Convention on Road Signs and Signals (1968)-

Group of Experts on Road Signs and Signals

Final report

Submitted by the Group of Experts on Road Signs and Signals

A, 19 c “INTERSECTION WITH A ROAD THE USERS OF WHICH MUST GIVE WAY”

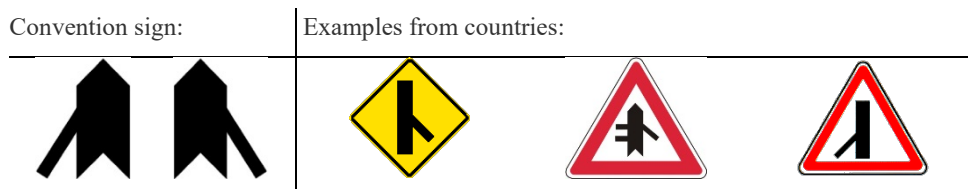
Some countries do not use the arrow head or the “V” shape at the bottom. The Group recommended using the symbol in the Convention without altering it (that is, having the arrow head and the “V” shape at the bottom). The Group clarified that the arrow head and the “V” shape at the bottom, and the differences in the proportion of the line widths, are essential characteristics of the symbol.

B, 4 “END OF PRIORITY”

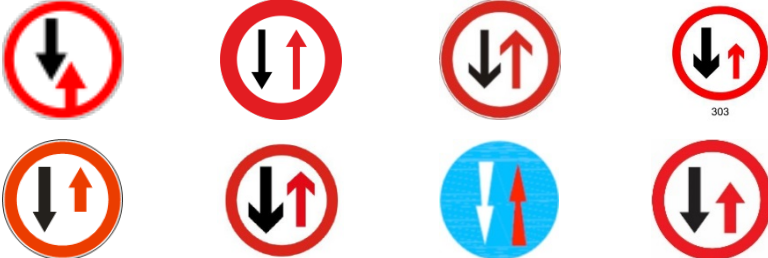
The Group noted that some countries do not use the black narrow strip for the yellow or orange square in the centre, and recommended that they do so.

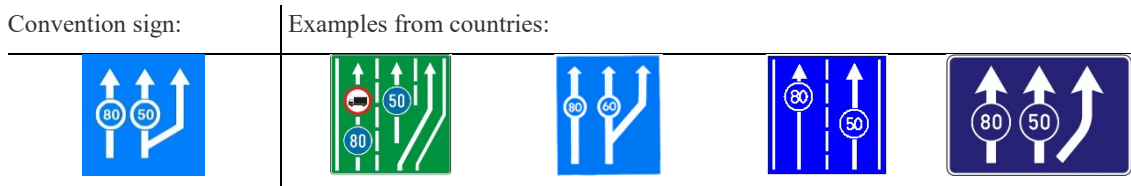
The Group noted that many countries use a white rim to enhance the sign’s conspicuity.

1. Azerbaijan, Hungary, Montenegro, Moldova, Russian Federation, Ukraine and Uzbekistan wrongly use examples for E, 1 b instead of E, 1 a.
2. Many countries use road markings (broken line) on this sign. The Group recommended the symbols on this sign not to include road markings ie., broken lines, as the arrows indicate the “lanes”.

3. The Group recommended that for the E, 1 a sign the sign D, 7 is used with a white rim.

E, 1 b “COMPULSORY MINIMUM SPEED APPLYING TO ONE LANE”

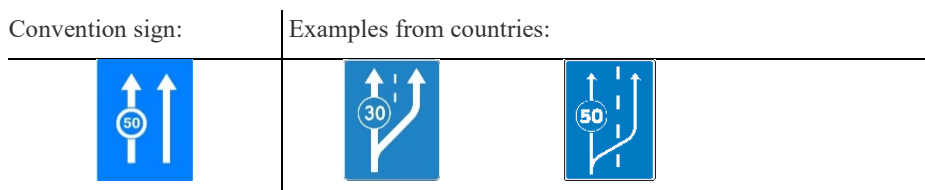
Albania, Croatia and Greece wrongly used examples for E, 1 a instead of E, 1 b.

Many countries use road markings (broken line) on this sign. The Group recommended the symbols on this sign not to include road markings ie., broken lines as the arrows indicate the “lanes”.

The Group recommended that for the E, 1 b sign the sign D, 7 is used with a white rim.

E, 1 c “SPEED LIMITS APPLYING TO DIFFERENT LANES”

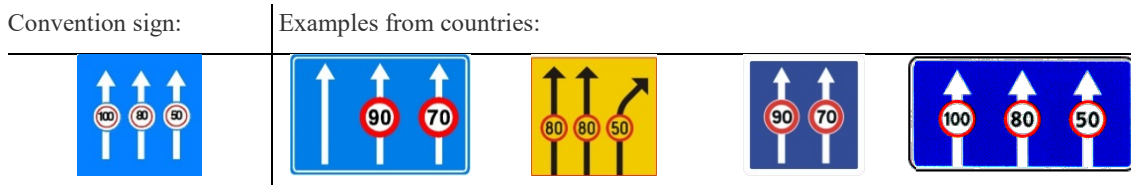
Azerbaijan used a wrong example for E, 1 c sign (truck entry prohibition sign instead of speed limit sign).

The Group recommended that the E, 1 c sign is improved by placing the sign C, 14 on the arrows and adding a white rim.

G, 2a and G, 2b “NO THROUGH ROAD” (advance direction signs)

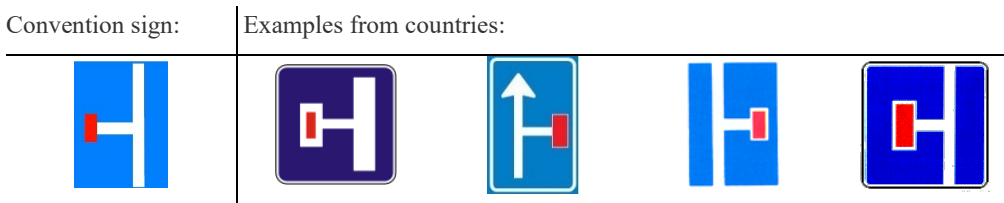
1. The Group also noted that the G, 2a Slovakian sign had a white border, instead of a rim, around the red bar. The Group further noted that the G, 2a sign from the Netherlands contained an arrow. The Group considered these signs not to be in conformity with the Convention.
